LiDAR Quality Assessment Report

MO_LincolnCo_2011

MO_Grand_2011

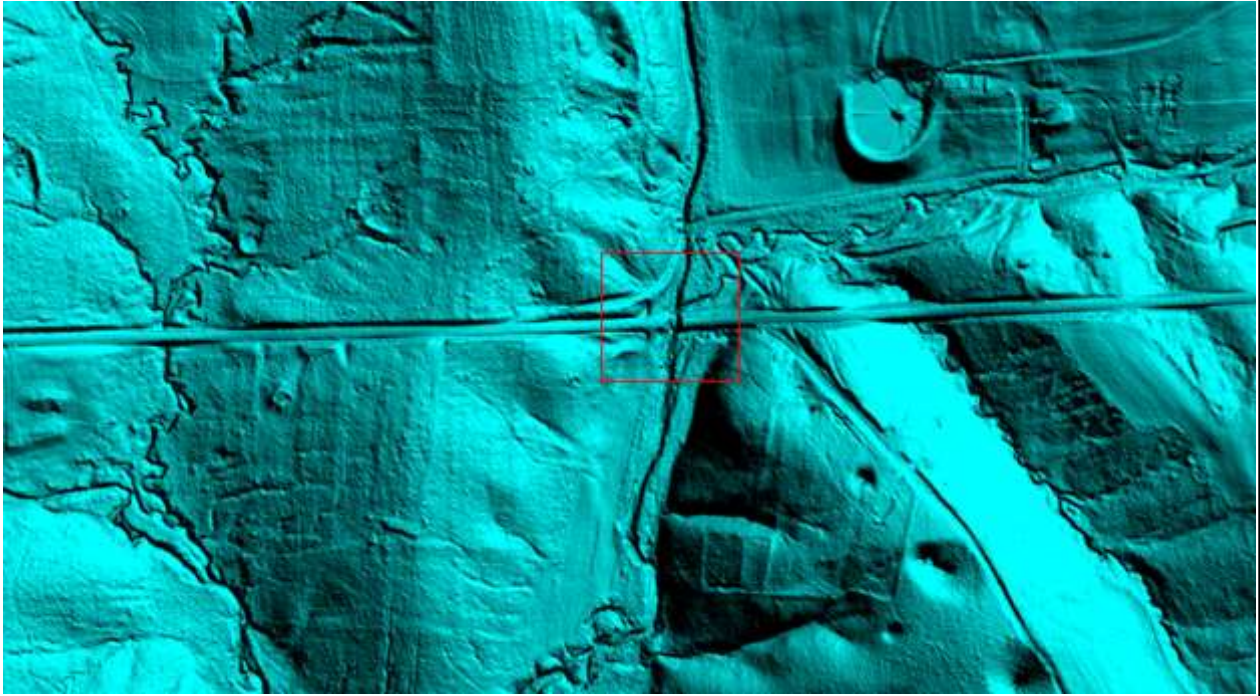
Culvert removal at 39° 10' 34.0276" N, 90° 47' 4.5208" W

**This error has been fixed by contractor.

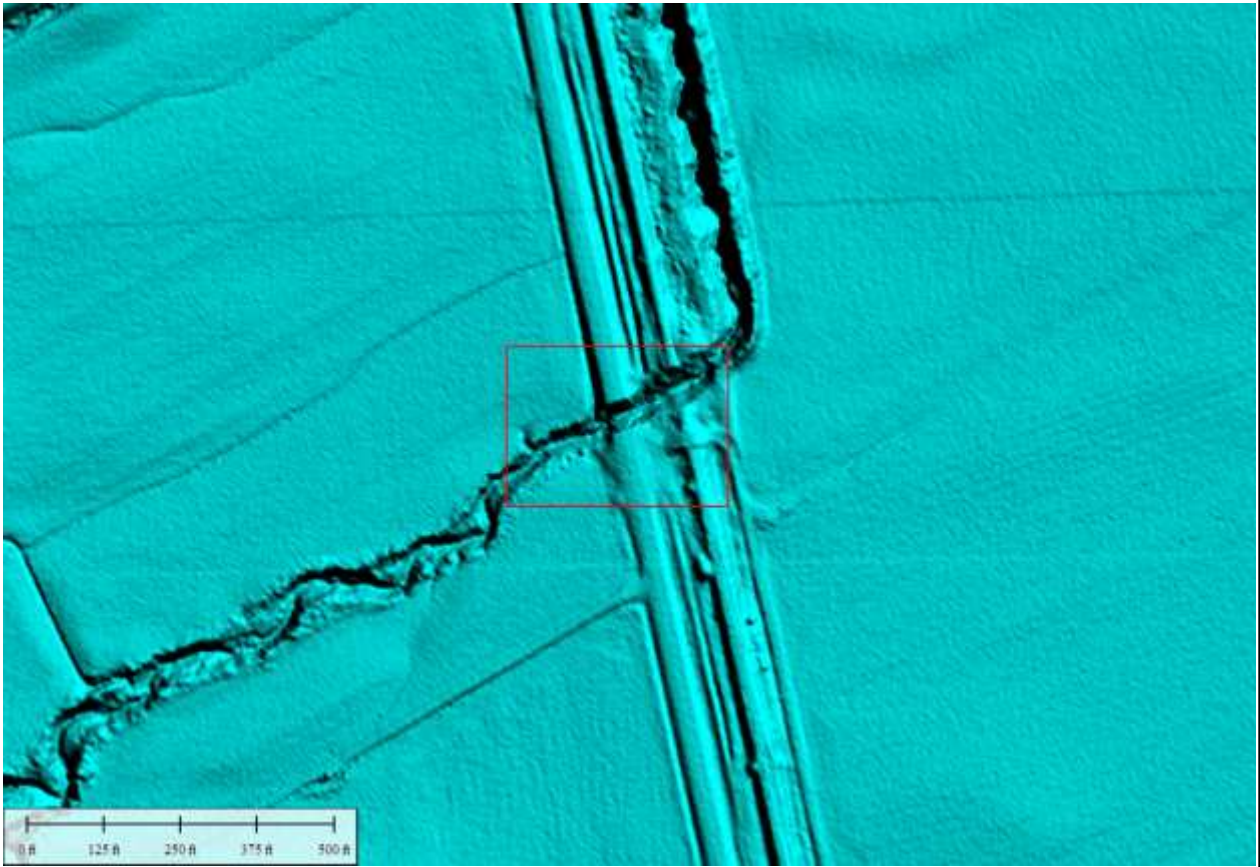
Culvert removal at 39° 03' 38.9451" N, 90° 54' 20.1754" W

**This error has been fixed by contractor.

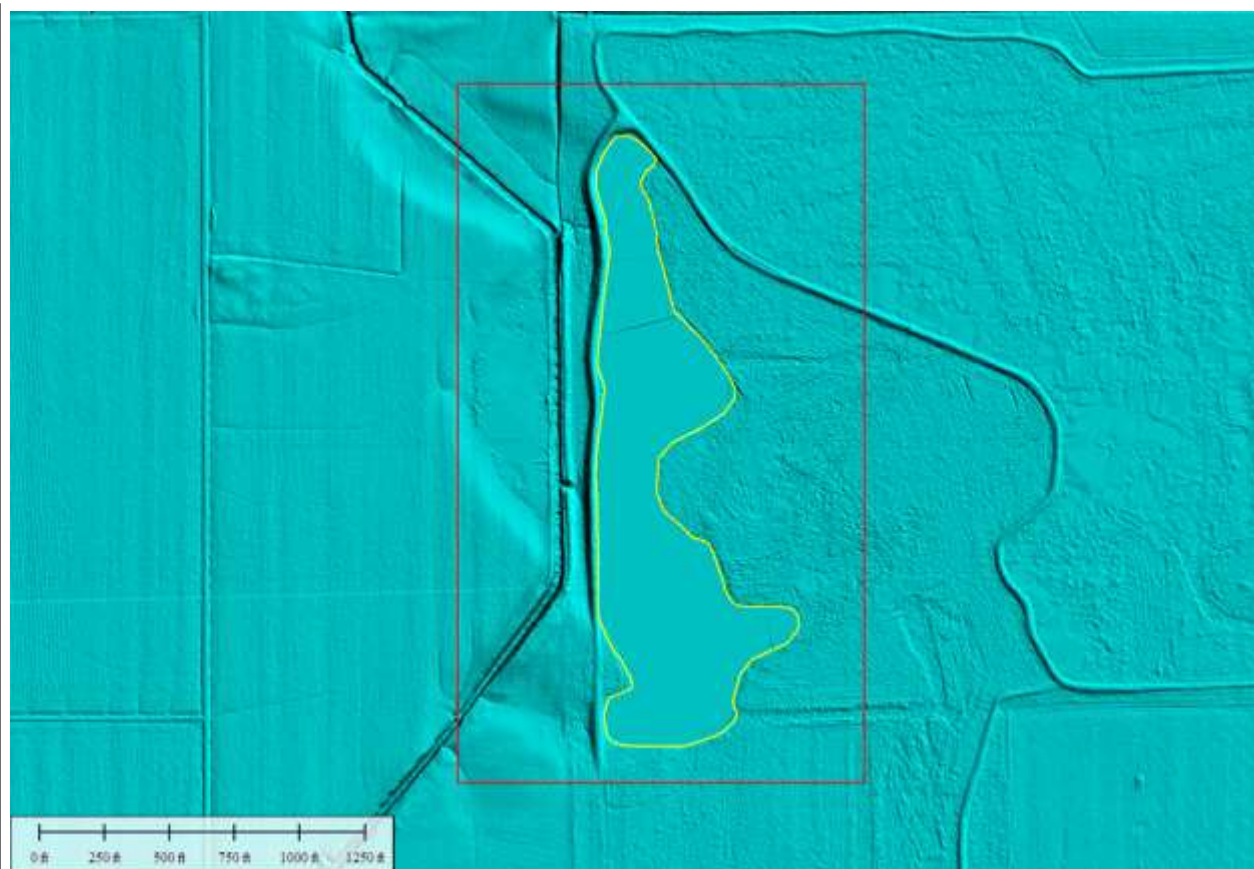
culvert_1: This is a representative image of roadways being removed above culverts. There are an additional 20 culvert-errors encountered in the DEM.

**These errors have been fixed by contractor (5/22/2013)
